STATE OF NORTH CAROLINA  
DEPARTMENT OF TRANSPORTATION

Subject: **Revision to Permit Application for an Individual Section 404 and Section 401 Water Quality Certification** for the widening of NC 49 from East of NC 73 to East of SR 2630 (Cline Road) in Cabarrus County. Federal Aid Project No. NHS-0049(26), Division 10, TIP No. R-2533CC.

Reference: Individual Permit Application dated September 7, 2010

Permit Drawing  
Sheet 6 of 51  
Revised 12/13/10

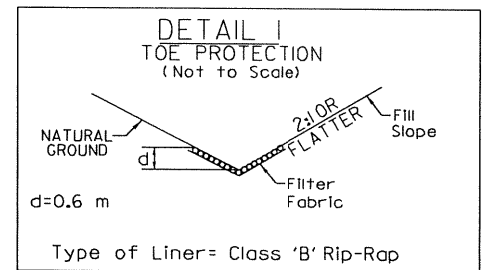
An additional revision has occurred to the permit summary sheet (Permit Drawing Sheet 6). An error has been discovered in the conversion of the metric impact numbers and the English impact numbers. This has resulted in the decrease of 19 linear feet of permanent stream impact due to the 2 @ 2.7 x 2.7 RCBC at Site 6. The bank stabilization at Site 6 has increased by 17 linear feet. The overall permanent stream impacts for R-2533CC is now 3058 linear feet, a decrease of

2 linear feet from the original permit application. These changes affect only the English version of the Permit Summary Sheet and do not change the metric version. No new areas or impacts are included in this revision.

Permit Drawing  
Sheet 11 of 61  
Revised 12/13/10

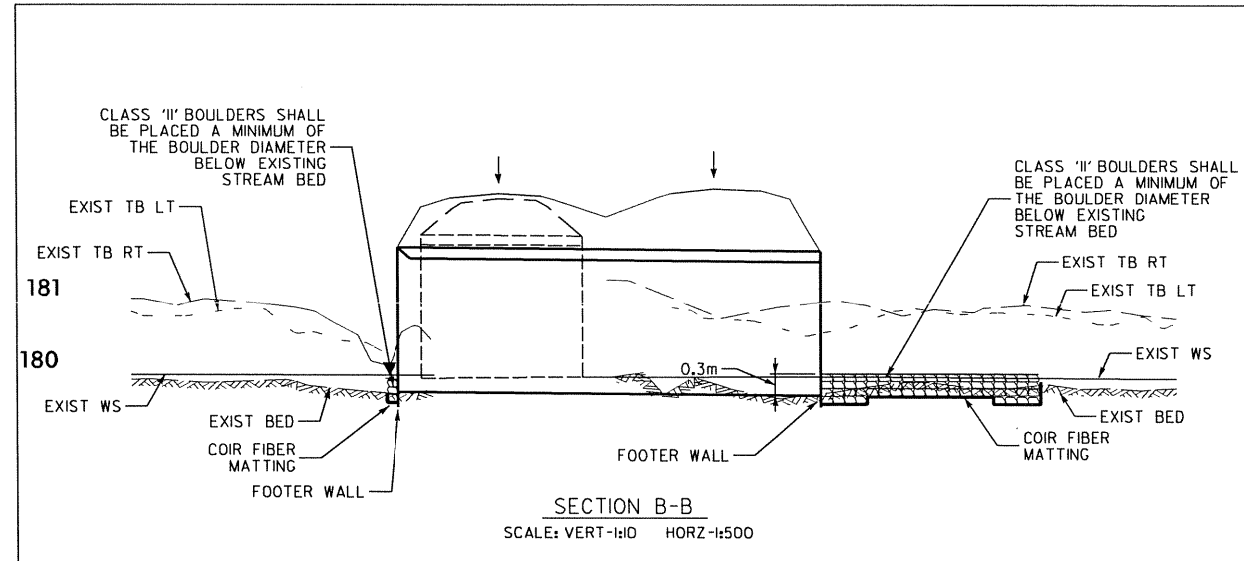
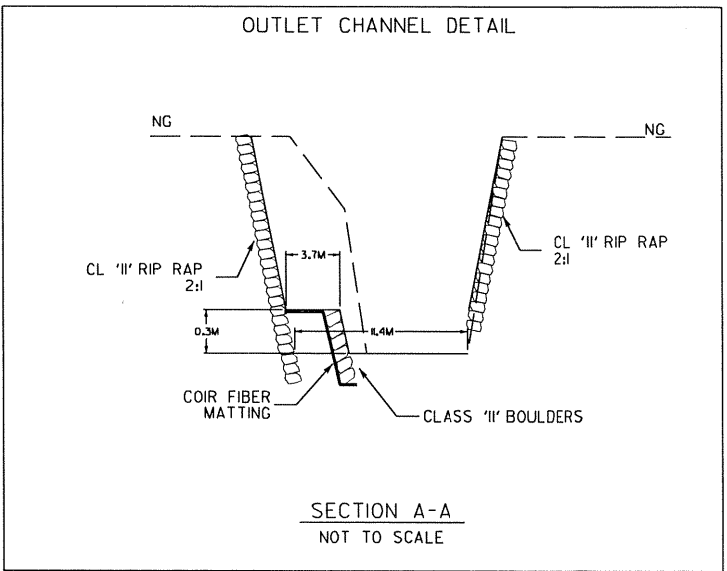
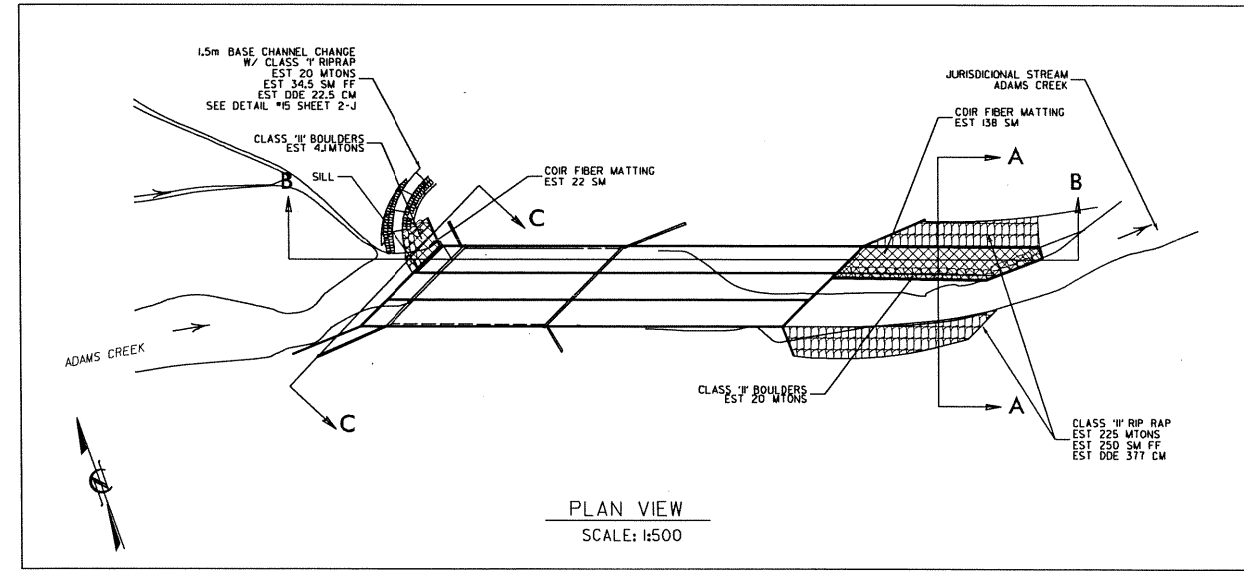
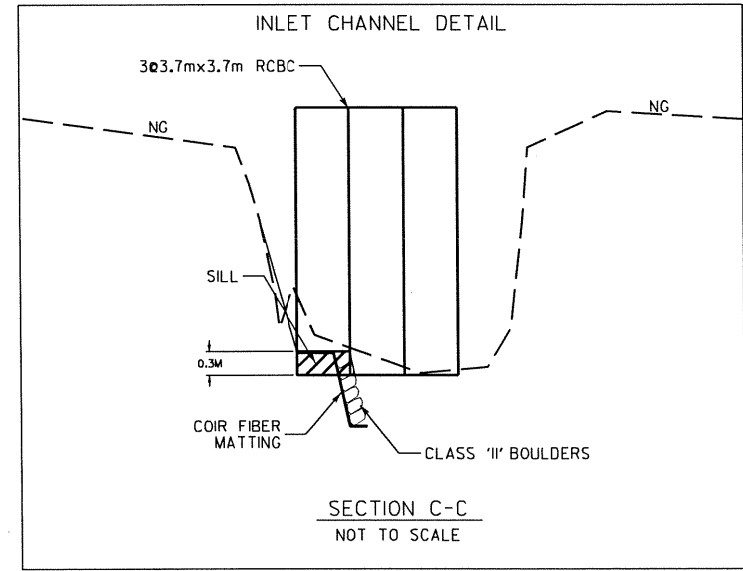
Please see attached, revised permit drawings and roadway drawings. Revisions to the following drawings are a result of comments received from NCDWQ on November 8, 2010 (see attached e-mail). Revisions have been made to drawings at Site 1 (Permit Drawing Sheets 11, 12, 13 and Roadway Sheets 2-Y and 6), Site 4 (Permit Drawing Sheets 20 and 21), Site 6 (Permit Drawing Sheets 23, 24, 35 and 36), the detail sheet (Permit Drawing Sheet 9, Roadway Sheet 2-J) and the overview sheets of Sites 4 – 9 (Permit Drawing Sheets 18, 19 and Roadway Sheet 11). The revisions in these drawings address the change in size of rip-rap at the outfall of these culverts comprised of two or more barrels from Class "I" to Class "II".

- NOTES:
- A BENCH 0.3m ABOVE THE BED SHALL BE ARMORED WITH BOULDERS AS SHOWN ON THE PLAN VIEW. THE DEPTH OF ARMOR PROTECTION SHOULD EXTEND 0.45m BELOW THE STREAM BED AND LINED WITH COIR FIBER MATTING.
  - DIMENSIONS AND SLOPES MAY BE ADJUSTED TO FIT BY THE ENGINEER.
  - EDGE ARMOR CAN BE NATURAL STREAM BOULDERS OR EXTRACTED FROM CLASS II RIPRAP OR SHOT ROCK MATERIAL AND CAN BE CUBICAL OR RECTANGULAR IN NATURE.
  - ACCEPTABLE BOULDERS FOR THE EDGE ARMOR SHALL HAVE THE FOLLOWING APPROXIMATE DIMENSIONS; 0.9m x 0.6m x 0.3m. UNSUITABLE EDGE ARMOR MATERIAL THAT REMAINS FROM CLASS II RIP RAP OR SHOT ROCK STORES, MAY BE USED IN BACK FILL OF THE OVER BANK AREA OR DISCARDED.
  - COIR FIBER MATTING SHALL EXTEND FROM THE BOTTOM OF THE FOOTER BOULDERS AND ACROSS THE BENCHED AREA TO PREVENT WASHOUT OF SEDIMENT THROUGH BOULDER GAPS.

Permit Drawing Sheet 20 of 51

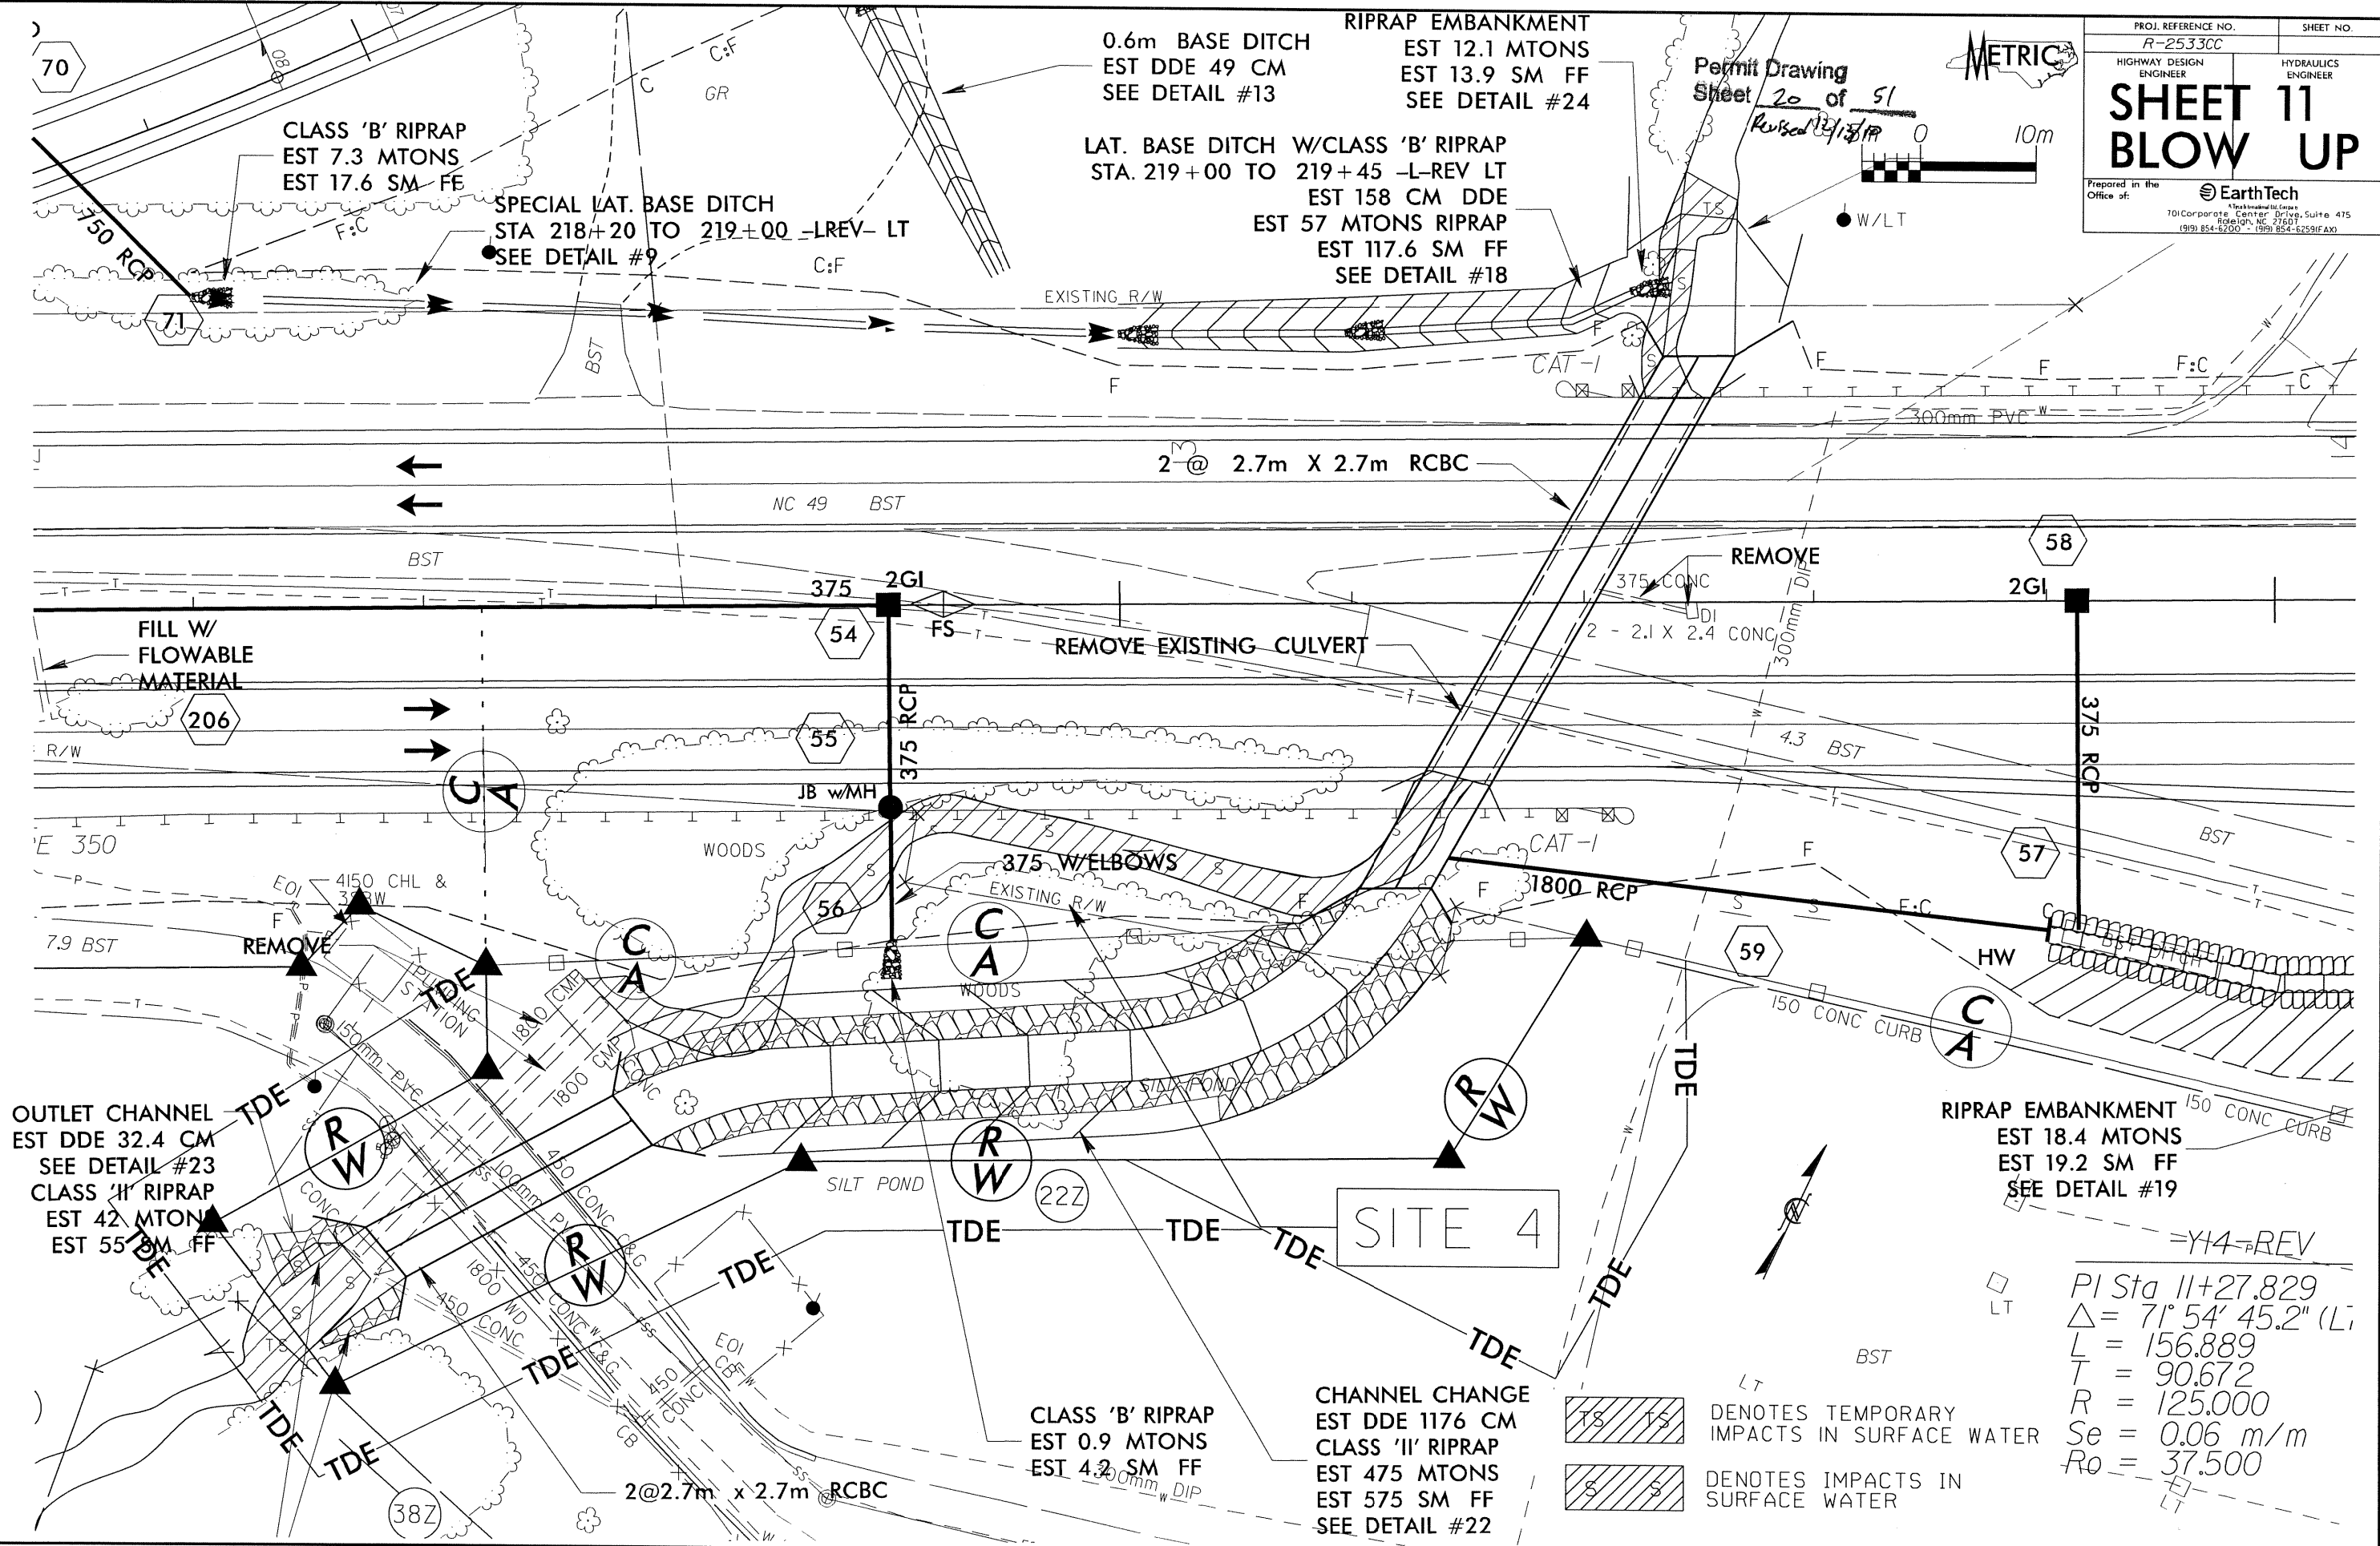
A further revision occurs at Site 4 (Permit Drawing Sheets 18, 20, 21 and Roadway Sheet 11). This revision involves the outfall of a stream into the Site 4 stream. The original design called for the piped Site 7 stream to enter the Site 4 stream at the headwall of the first culvert. A design change calls for the piped Site 7 stream to enter the Site 4 stream approximately 10 feet (3 meters) inside of the first culvert. This design change will help to dissipate flow from the Site 7 stream better than the previous design.

OUTLET CHANNEL  
EST DDE 32.4 CM  
SEE DETAIL #23  
CLASS 'H' RIPRAP  
EST 42 MTONS  
EST 55 SM FF

CHANNEL CHANGE  
EST DDE 1176 CM  
CLASS 'H' RIPRAP  
EST 475 MTONS  
EST 575 SM FF  
SEE DETAIL #22

Permit Drawing  
Sheet 35 of 51

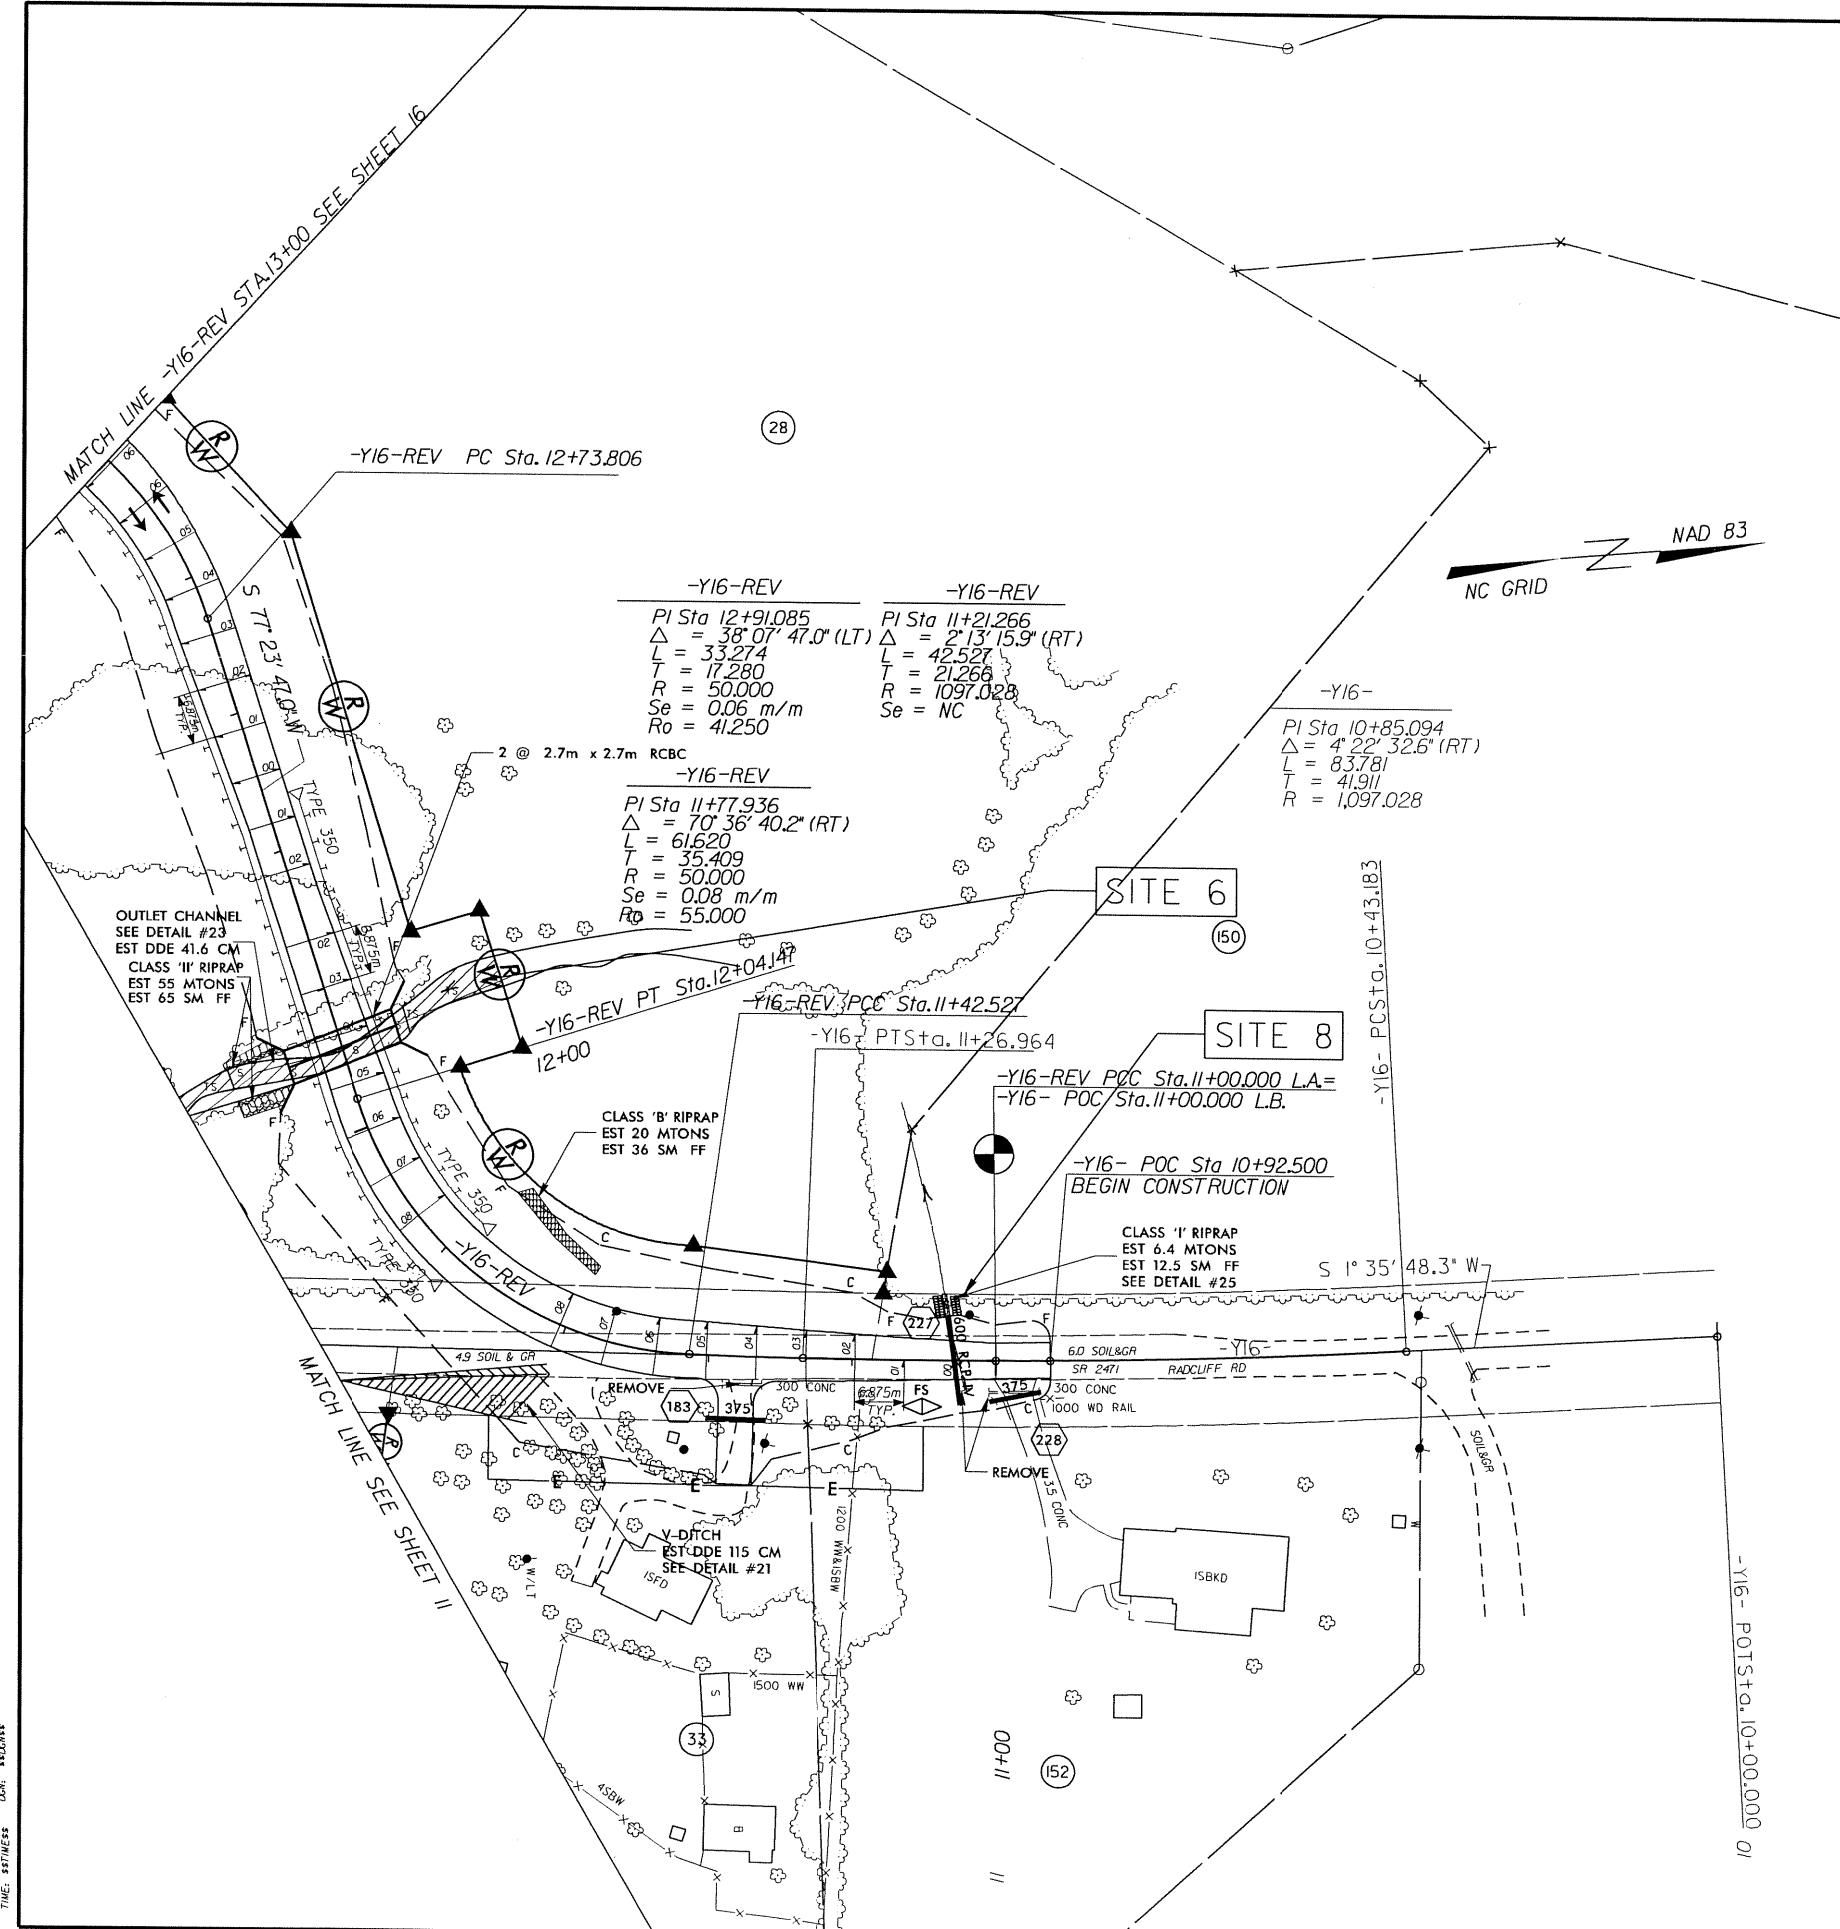
- Permit Site 5 – It appears that this stream will be relocated to a culvert (upper reach) and then to a ditch (lower reach). If the upper reach will be piped, how is the stream going to get into the pipe? The plans show the stream (depicted as impacted) with the culvert parallel to it, but I don’t see a spring box or other mechanism to get the stream into the pipe. Please clarify.
